#### CHATHAM COUNTY PURCHASING & CONTRACTING DEPARTMENT

### ADDENDUM NO. 1 TO 13-0044-4

FOR: CHATHAM C	COUNTY HUMAN	N RESOURCES	OFFICE AT	Γ 123 ABERC	ORN
STREET

A1 BASEMENT FLOOR PLAN - HVAC

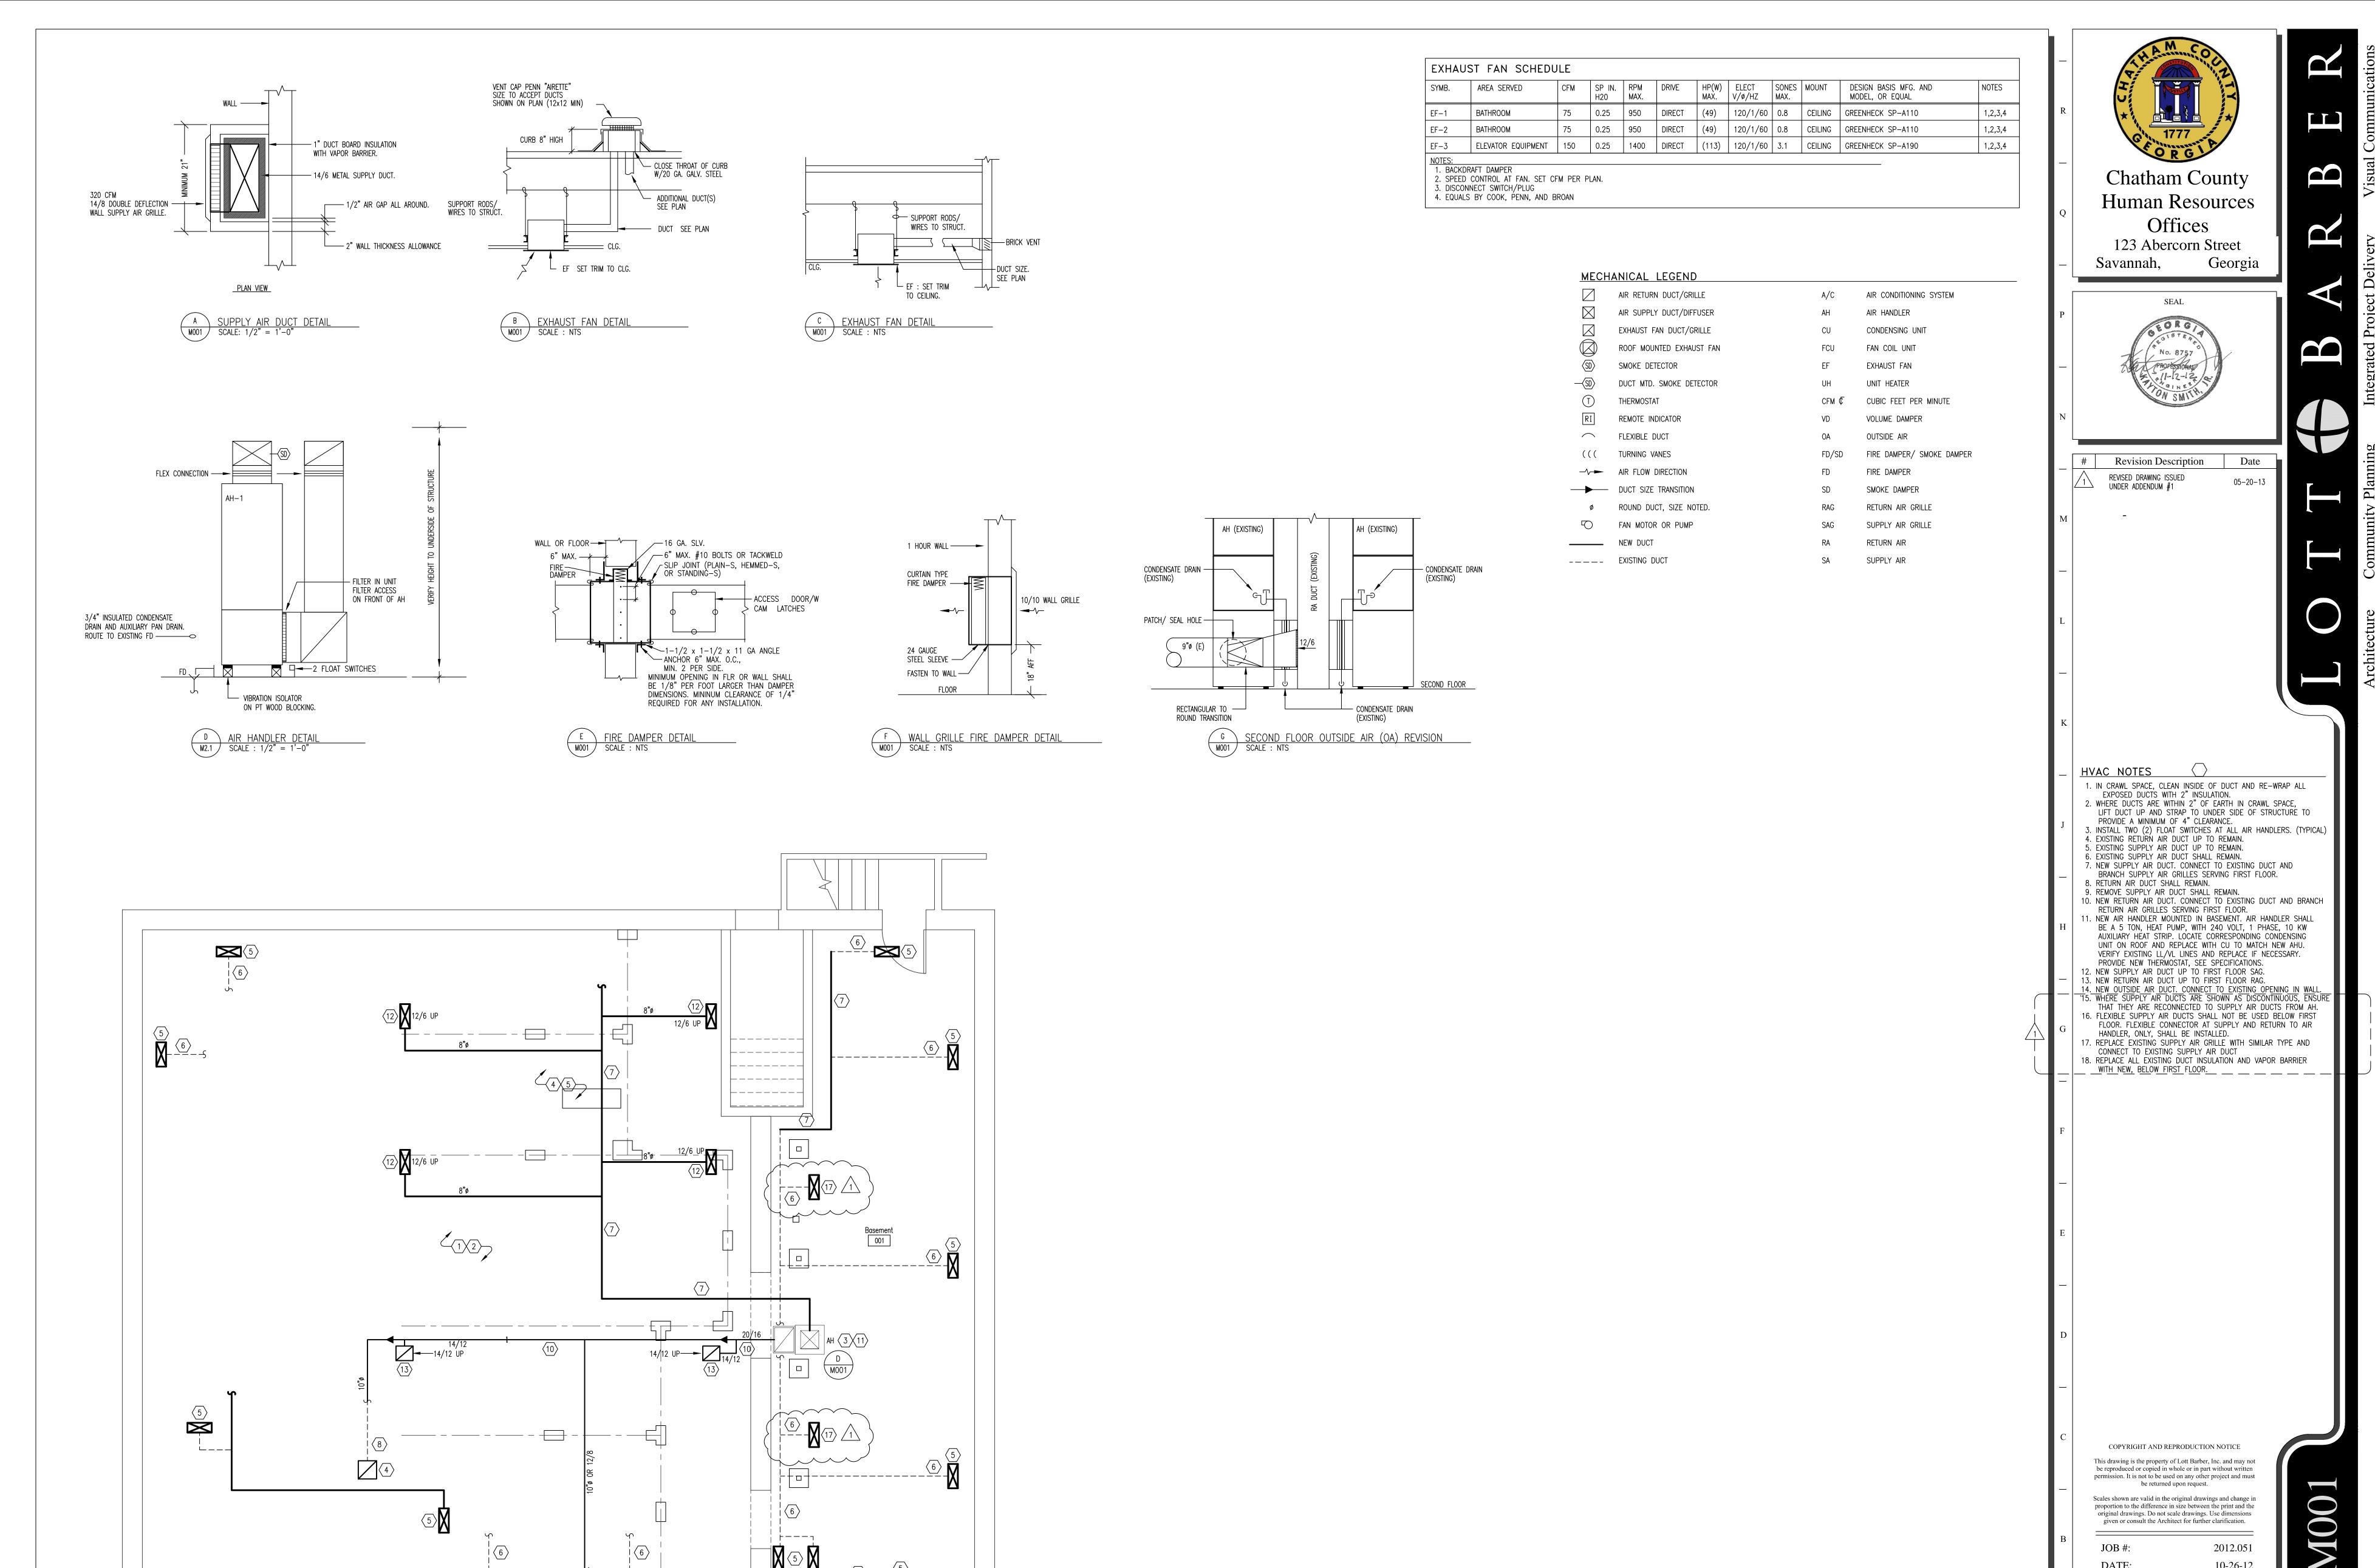
- 1. Sheet S101, dated 6/5/13
- 2. Sheet A100, dated 6/4/13
- 3. Sheet ID000, dated 6/4/13
- 4. Sheet M001, dated 5/20/13
- 5. Sheet M101, dated 5/20/13
- 6. Sheet D101, dated 5/20/13
- 7. Sheet E101, dated 5/20/13
